December 2008  
Fuji Electric Systems Co., Ltd.  
Controller Div.  
Automation & Solution Business  
Headquarters

## **MICREX-SX Series** **Notice of Functional Expansion of Board Controller** **(SPB Version)**

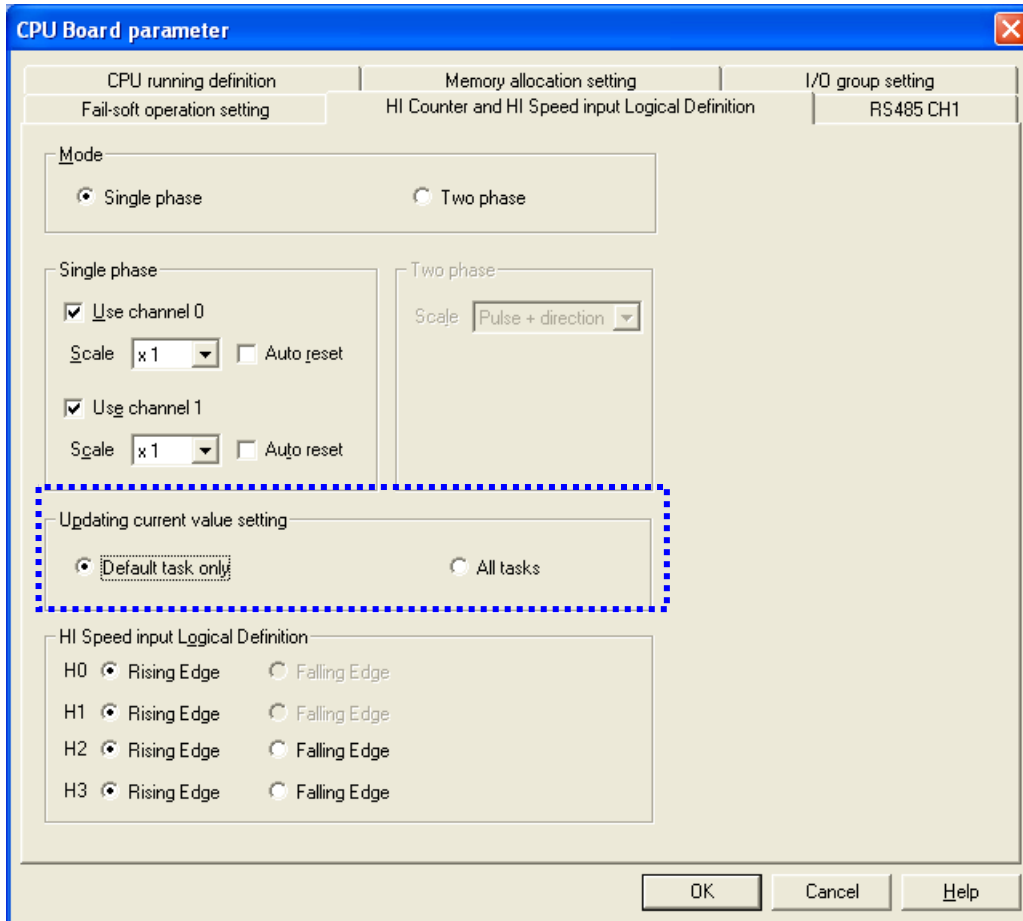
- (1) The change has been applied to products manufactured since November 2008.
- (2) Applicable versions  
The expanded function is supported by firmware version V06 or higher.
- (3) The prices and model numbers remain unchanged.
- (4) The version the SX-Programmer Programming Support Tool must be updated to use the expanded function.
  - Expert (D300win) V3 (NP4H-SEDBV3): V3.4.5.0

With the new version, it is possible to update the current value of a high-speed counter in synchronization with a scheduled task or event task.

Conventionally, the current value of a high-speed counter was updated in synchronization with the execution of the default tasks, which involved a maximum execution time delay equivalent to the execution cycle of the default tasks.

With this expansion, the current value can be updated in synchronization with the execution of an individual task. Therefore, the execution time delay of the current value read in each task will be limited to a maximum period of the task execution time.

The updating of current value setting is by default set to *Default task only* to maintain compatibility with the previous version of the Board Controller.
